IMPORTANT PRODUCT INFORMATION

Product: Series 90-30 CPU Modules with Firmware Release 10.75

CPU Problems Resolved by Firmware Revision 10.75

GFK-1512S

In table 12-13 on page 12-82 of GFK-0467M, the Config Word row should be replaced with:

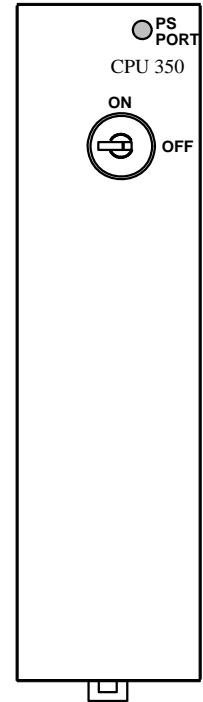
Optional filtering may now be applied to the PID Derivative Term to improve control loop stability in some applications. Filtering may be enabled by setting bit 5 (previously unused) in the Config Word parameter of the PID Parameter Block.

The following changes will be made to the *Series 90™-30/20/Micro PLC CPU Instruction Set Reference Manual*, GFK-0467M, at its next revision:

In Chapter 12, "Control Functions", Section "*PID Algorithm Selection (PIDISA or PIDIND) and Gains*"

The description of the Derivation term should be replaced with this text:

%Ref+0012	Config Word	Low 6 bits used	<p>Bit 0: Error Polarity. When this bit is 0, the error term is SP - PV. When this bit is 1, the error term is PV - SP. Setting this bit to 1 modifies the standard PID Error Term from the normal (SP - PV) to (PV - SP), reversing the sign of the feedback term. This is for reverse acting controls where the CV must go down when the PV goes up.</p> <p>Bit 1: Output Polarity. When this bit is 0, the CV output represents the output of the PID calculation. When it is set to 1, the CV output represents the negative of output of the PID calculation. Setting this bit to 1 inverts the Output Polarity so that CV is the negative of the PID output rather than the normal positive value.</p> <p>Bit 2: When this bit is 1, the setpoint is removed from derivative calculation. For details, see the discussion on page 15.</p> <p>Bit 3: Deadband action. When the Deadband action bit is 0, no deadband action is chosen. If the error is within the deadband limits, the error is to be zero. Otherwise the error is not affected by the deadband limits.</p> <p>If the Deadband action bit is 1, deadband action is chosen. If the error is within the deadband limits, the error is forced to be zero. If, however, the error is outside the deadband limits, the error is reduced by the deadband limit (error = error - deadband limit).</p> <p>Bit 4: Anti-reset windup action. When this bit is 0, the anti-reset windup action uses a reset back calculation. When the output is clamped, this replaces the accumulated Y remainder value with whatever value is necessary to produce the clamped output exactly.</p> <p>When the bit is 1, this replaces accumulated Y term with the value of the Y term at the start of the calculation. In this way, the pre-clamp Y value is held as long as the output is clamped.</p> <p>Bit 5: Enable derivative filtering. When this bit is set to 0, no filtering is applied to the derivative term.</p> <p>When set to 1, a first order filter is applied. This will limit the effects of higher frequency process disturbances on the derivative term.</p>
